Access Compliance Report

Public Rights-of-Way

(Curb Ramps)

Intersection ID: 23312	Main Street: BALTUSROL_LN	Cross Street: GLENEAGLES_RD	Location: SW
ADA ID: 5E95833E09CC	Ramp Type: PerpDiag	Initial Pass/Fail: Fail	Overall Compliance: No
Severity Score: 8.75			
Codes/Mitigation Info/Possible Solution		Field Measurements/Component Compliance

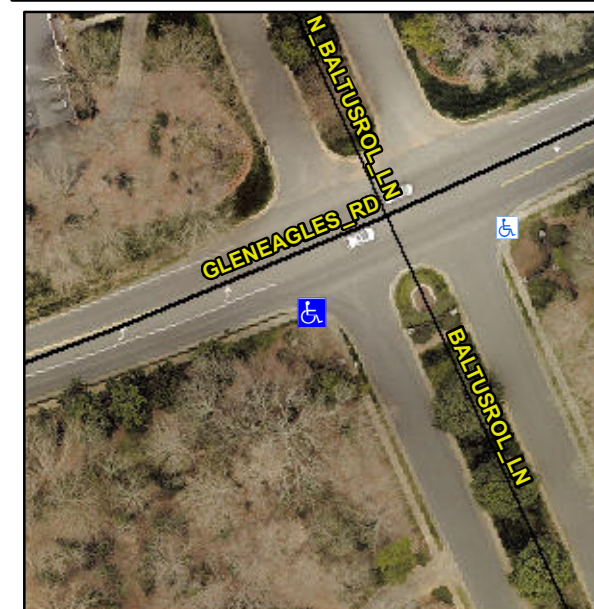
Not Found, R304.5.1

Compliance	Description	Data	Compliance	Description	Data
N/A	Ramp Length (in)	48.0	Yes	Ramp Slope (%)	6.8
No	Ramp Width (in)	46.5	Yes	Ramp XSlope (%)	0.5
N/A	Flare Type LT	N/A	N/A	Flare Type RT	N/A
N/A	Flare Slope LT (%)	N/A	N/A	Flare Slope RT (%)	N/A
N/A	Flare Traversable LT?	N/A	N/A	Flare Traversable RT?	N/A
N/A	Landing Length (in)	N/A	N/A	DWS Provided?	N/A
N/A	Landing Width (in)	N/A	N/A	DWS Contrast?	N/A
N/A	Landing Slope (%)	N/A	N/A	DWS Length (in)	N/A
N/A	Landing X Slope (%)	N/A	N/A	DWS Full Width?	N/A
N/A	Landing Curb? (Y/N)	N/A	N/A	DWS Offset (in)	N/A
N/A	Shared Landing?	N/A			
N/A	Gutter Ponding?	N/A	N/A	Gutter Slope (%)	N/A
N/A	Gutter Lip Ht (in)	N/A	N/A	Gutter X Slope (%)	N/A
N/A	Painted X Walk1?	No	N/A	Painted X Walk2?	No
	X Walk 1 Direction	To E		X Walk 2 Direction	To N
N/A	X Walk 1 Width (in)	N/A	N/A	X Walk 2 Width (in)	N/A
	X Walk 1 Slope (%)	1.6		X Walk 2 Slope (%)	5.7
	X Walk 1 X Slope (%)	3.7		X Walk 2 X Slope (%)	0.8

N/A	Ramp inside XWalk1?	N/A	N/A	Ramp inside XWalk2?	N/A
	Road Slope (%)	0.5	N/A	Clear Space?	N/A
	Road X Slope (%)	6.9	N/A	Clear Space to XWalk (in)	N/A
N/A	Any Obstructions?	N/A	N/A	Storm Grate/Utility Hazard?	N/A
	Obstruction Type			Storm Grate/Utility Type	
		N/A			N/A
		Yes		Surface Condition? (G/P)	Good

Remove & Replace Curb Ramp With Two New Directional Ramps or Equivalent.
